STATE OF ALASKA
LIBRARY ARCHIVES MUSEUM

Submittal #: 06 41 00-6.1

Specification: 06 41 00 Architectural Wood Casework

Description: Gift Shop Casework Shop Drawings

① SECTION - SLIDING GLASS ENTRY DOOR
1 1/2" = 1'-0"

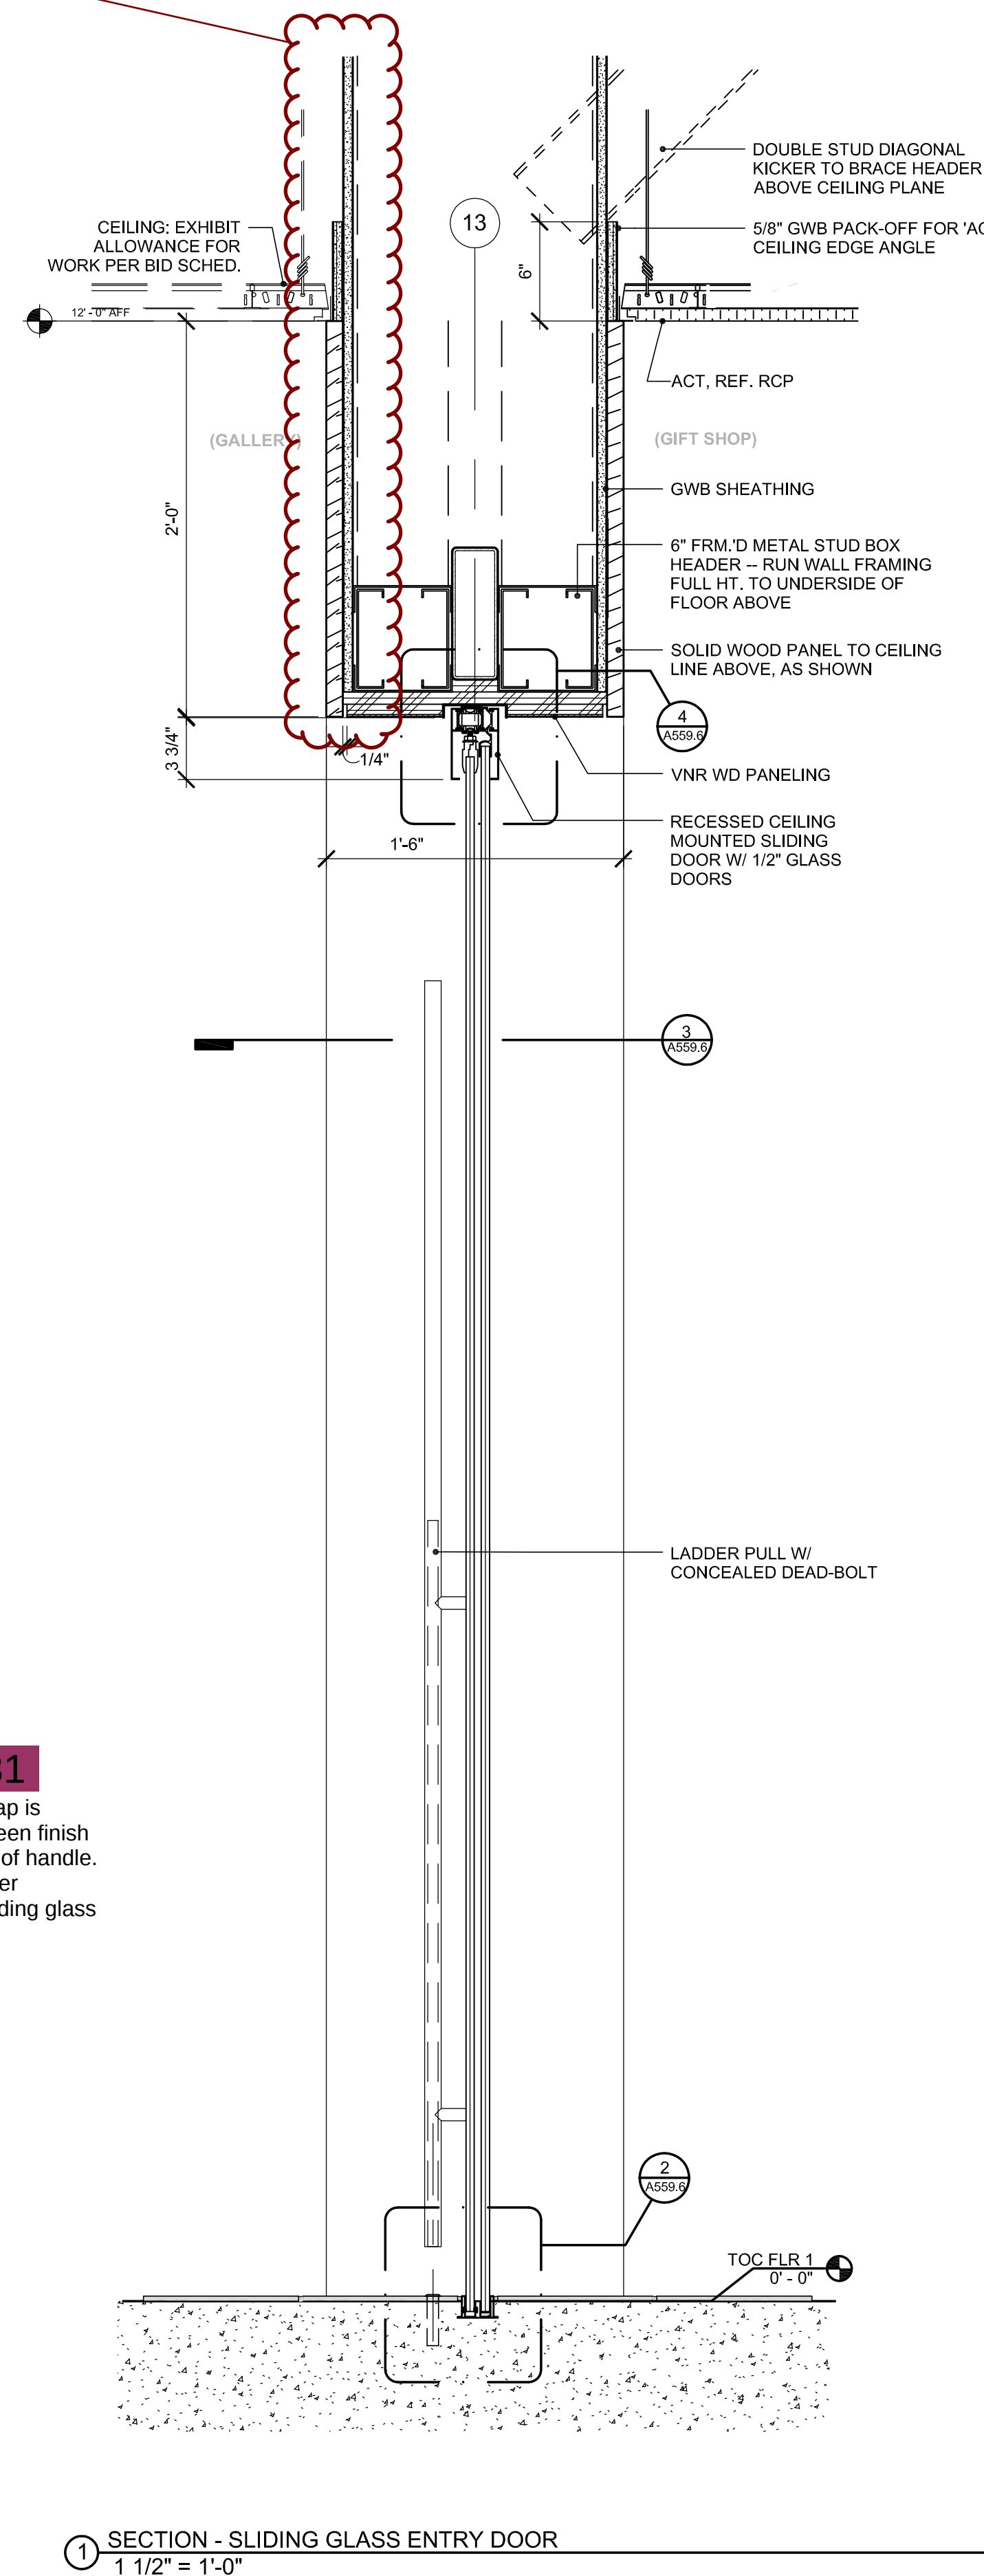
4/2/15 - A 1/4" gap is
acceptable between finish
floor and bottom of handle.
See RFI for further
clarification to sliding glass
door.

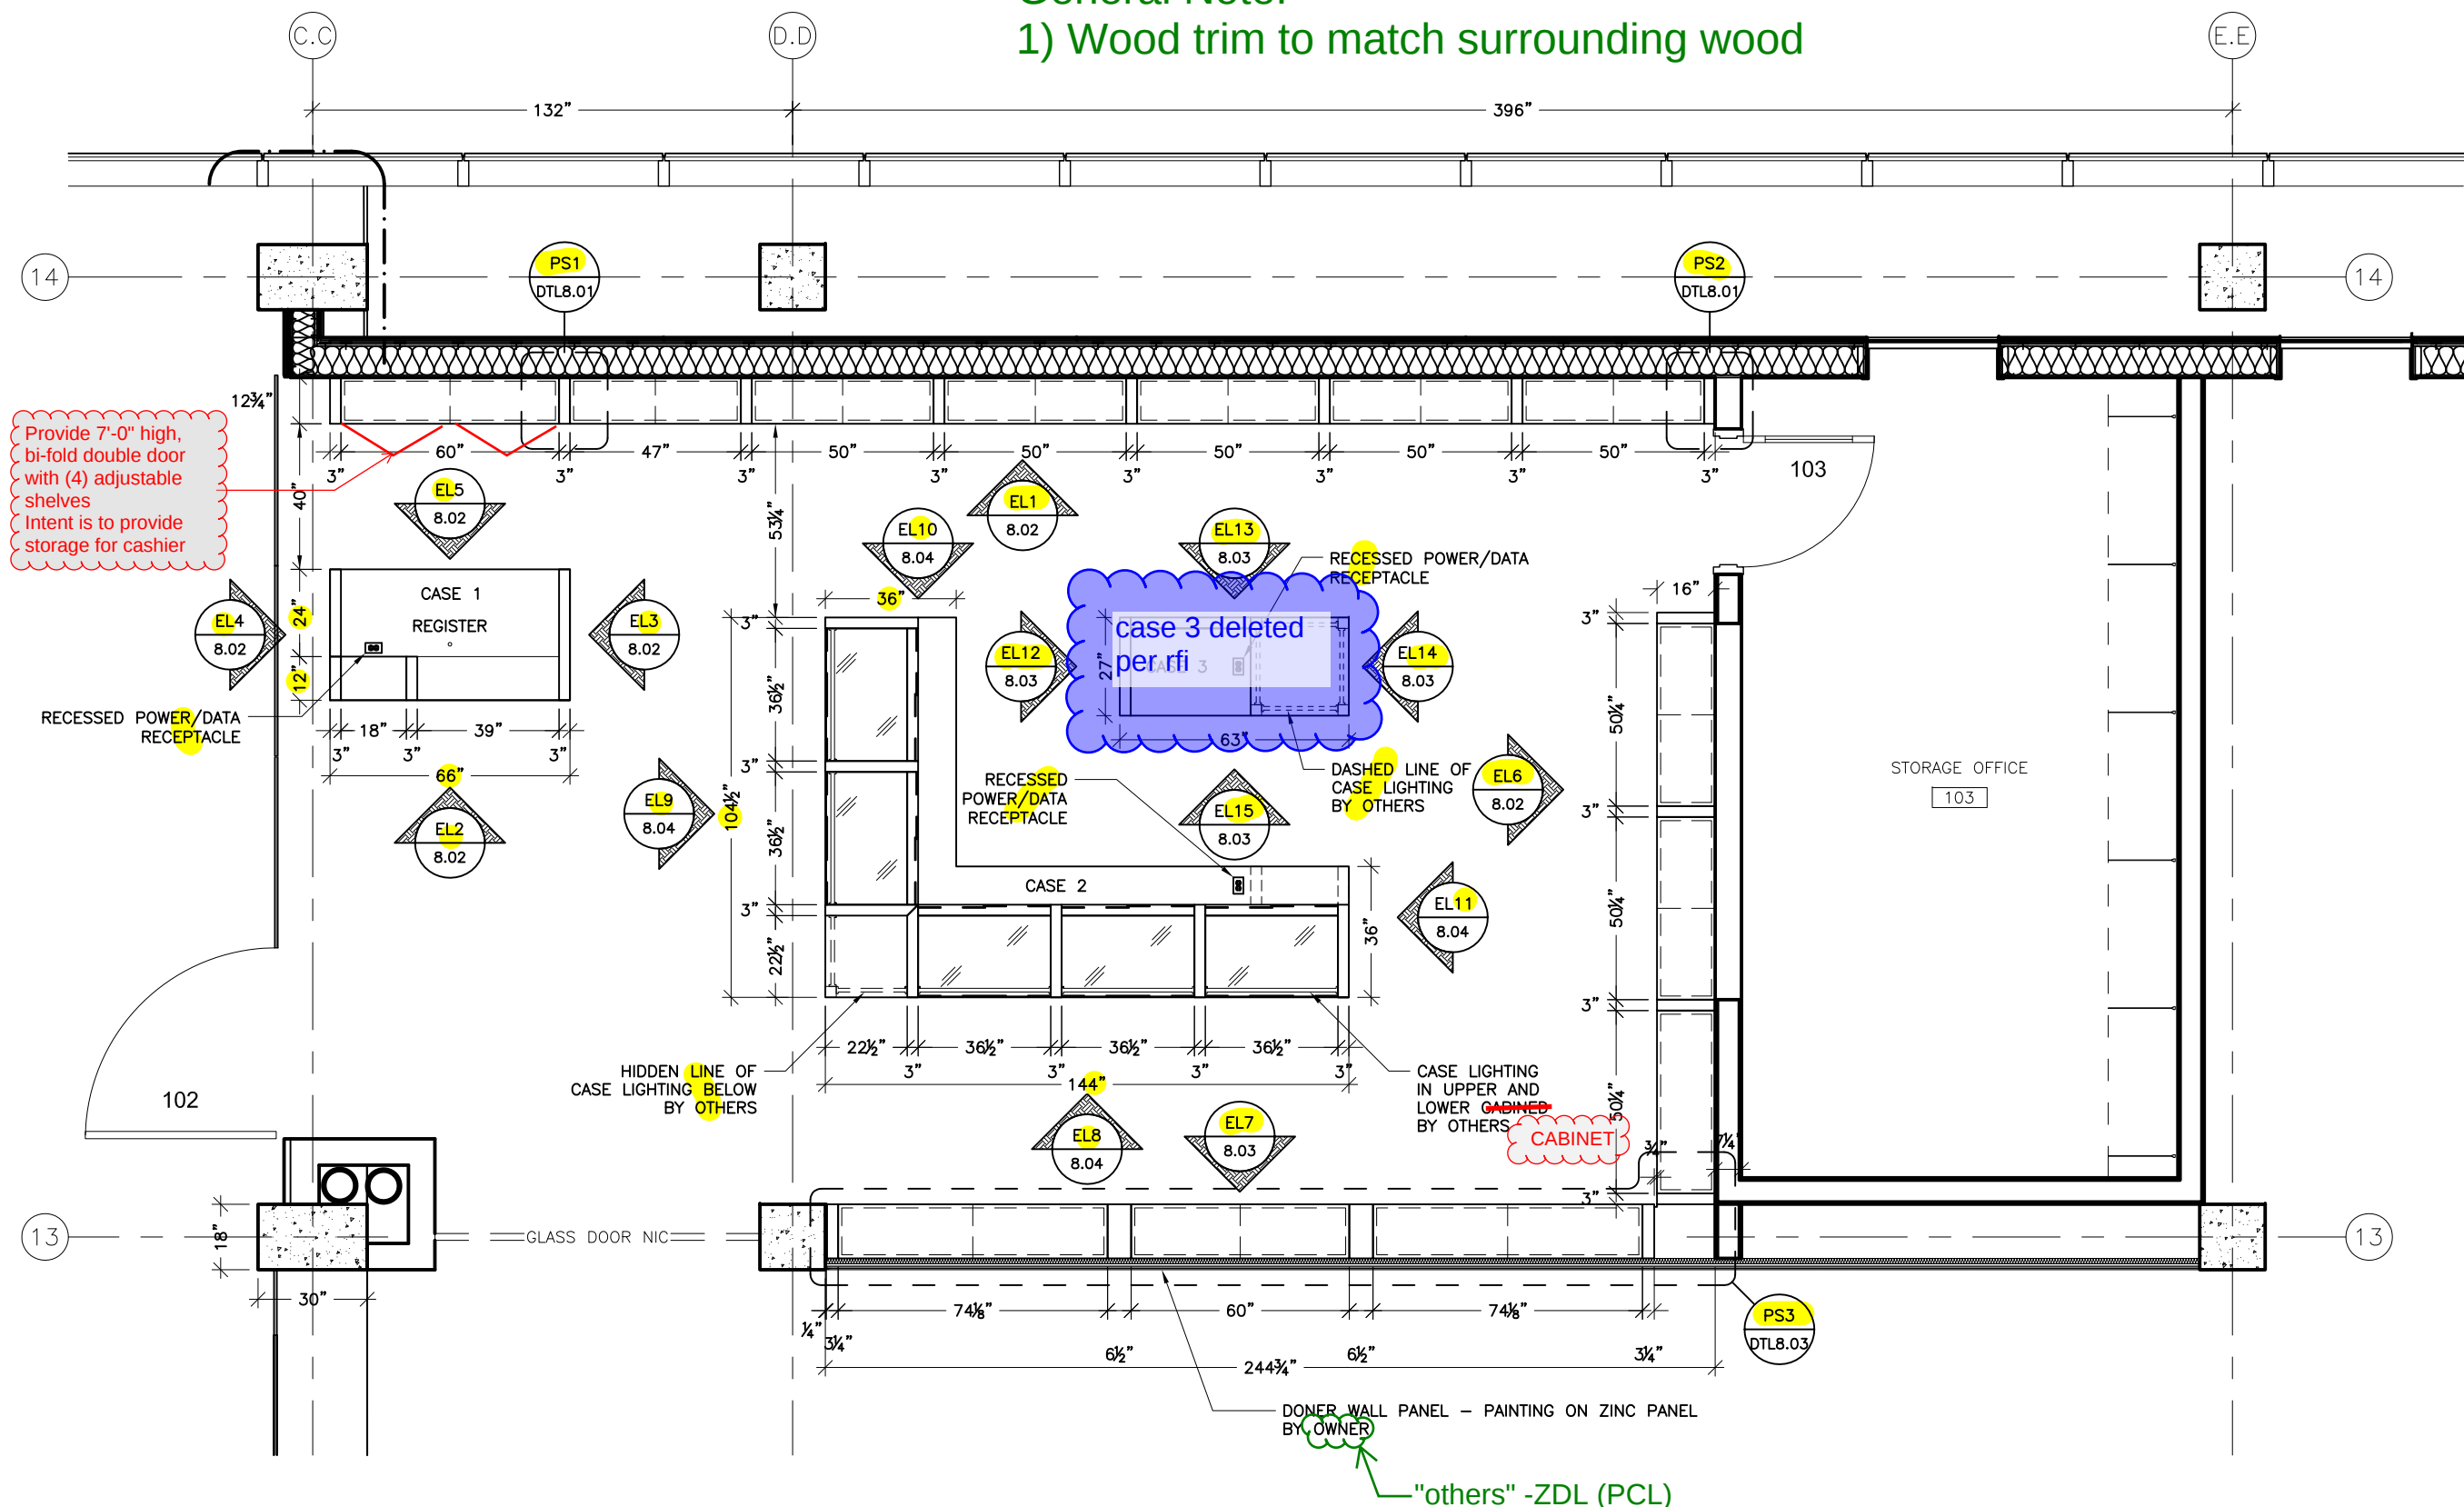
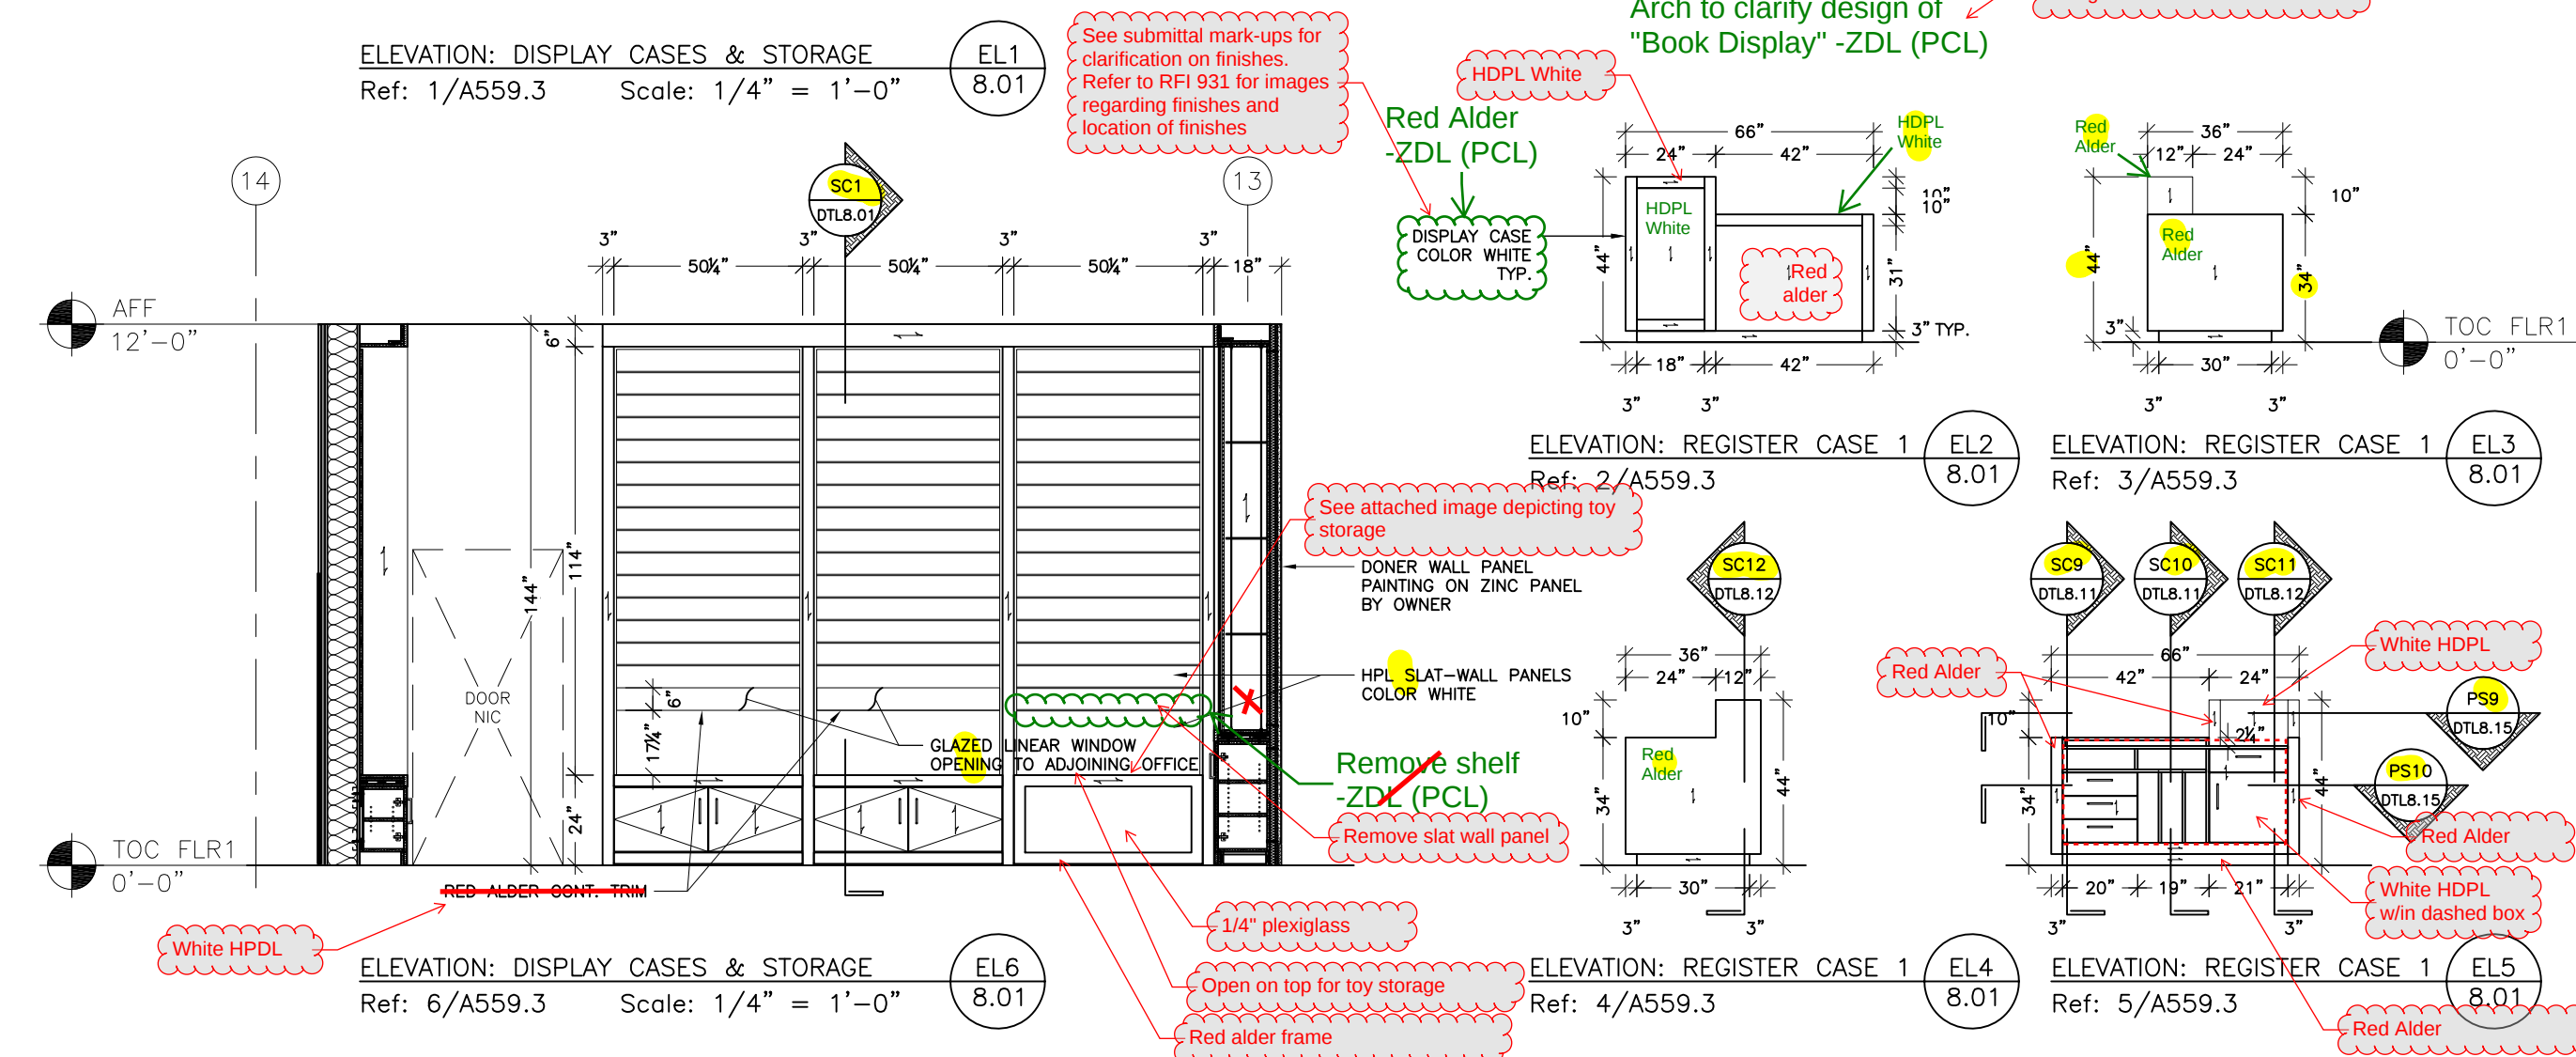
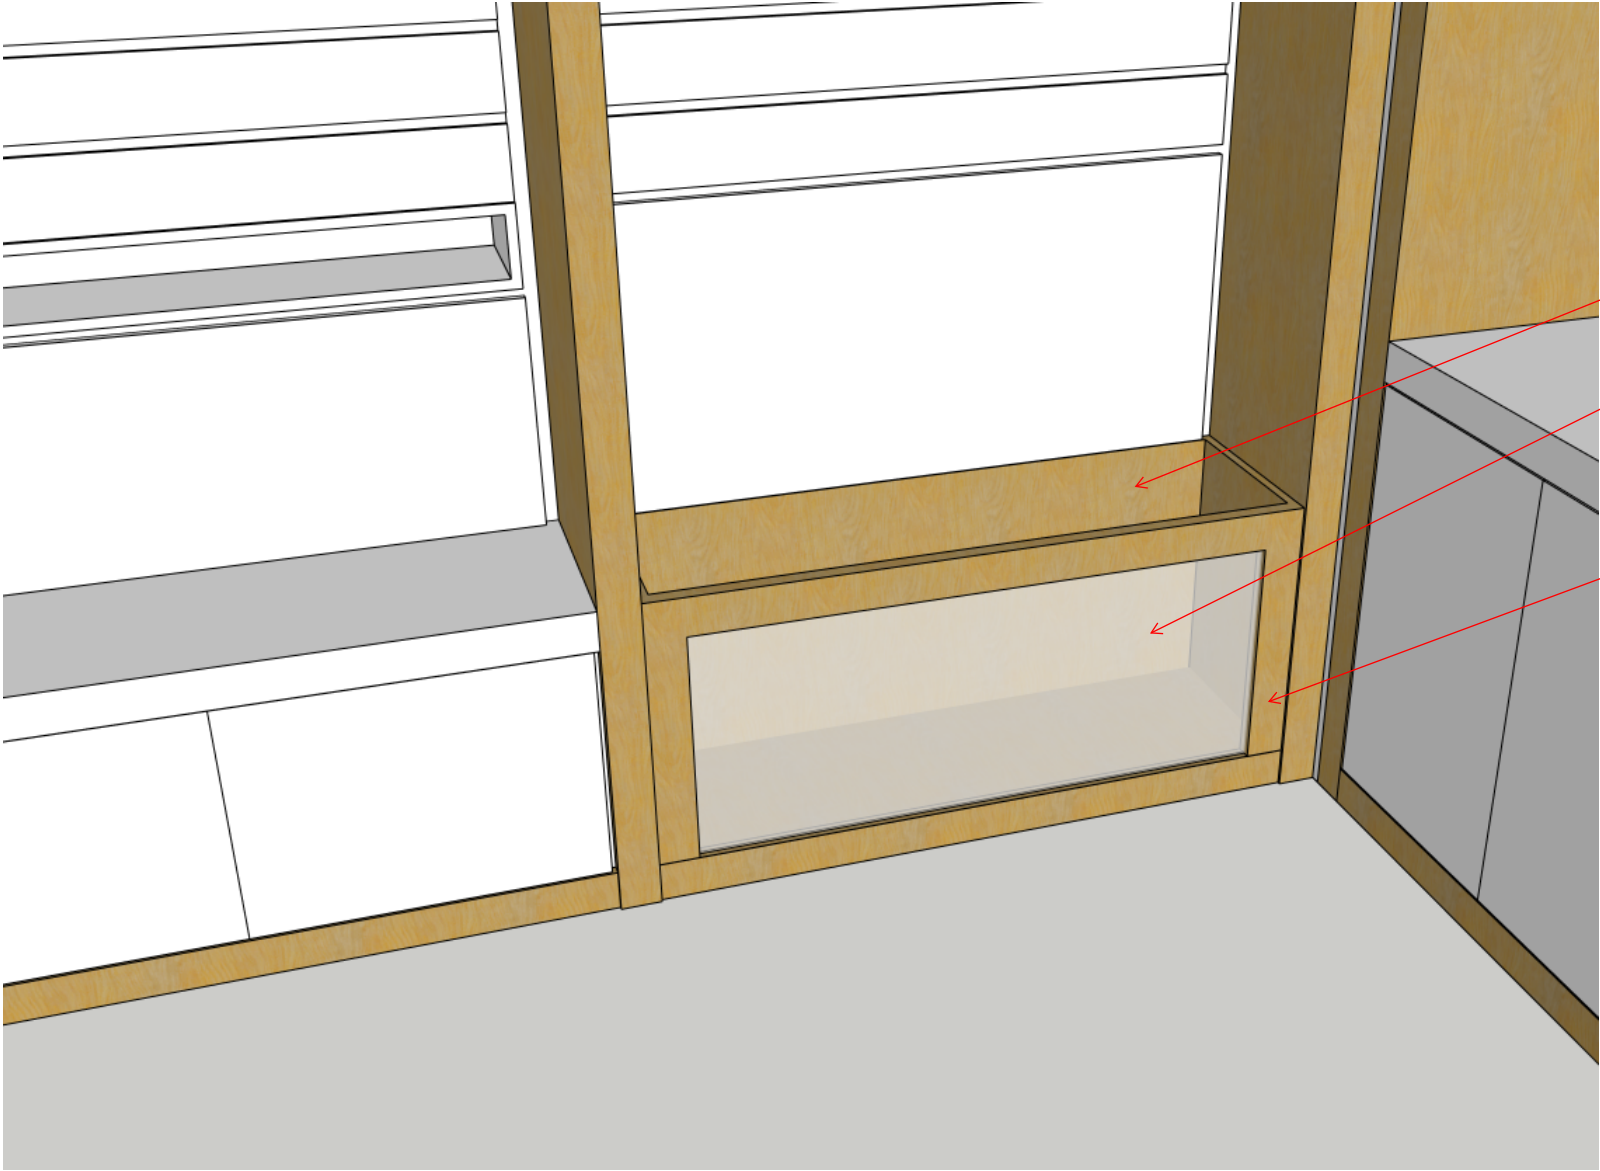
☐ NO EXCEPTION TAKEN ☒ MAKE CORRECTIONS NOTED ☐ REVISE AND RESUBMIT ☐ REJECTED	
		Review of submittals indicates conformance with the design concept of the project and compliance with the information given in the Contract Documents and shall not relieve the CONTRACTOR of the responsibility for compliance with the requirement of the Contract Documents; or for errors, dimensions, and quantities unless specific exception is requested and approved on the submittal.	
		DEPARTMENT's review shall not extend to the means, methods, techniques, sequences or procedures of construction or to safety precautions or programs incident thereto. The review and approval of a separate item as such will not indicate approval of the assembly in which the item functions.	
		SIGNED: <u>David Popiel</u> DATE: <u>7/21/15</u>	
		Notes - See attached submittal for comments - Note request for RFI regarding transparent book enclosure
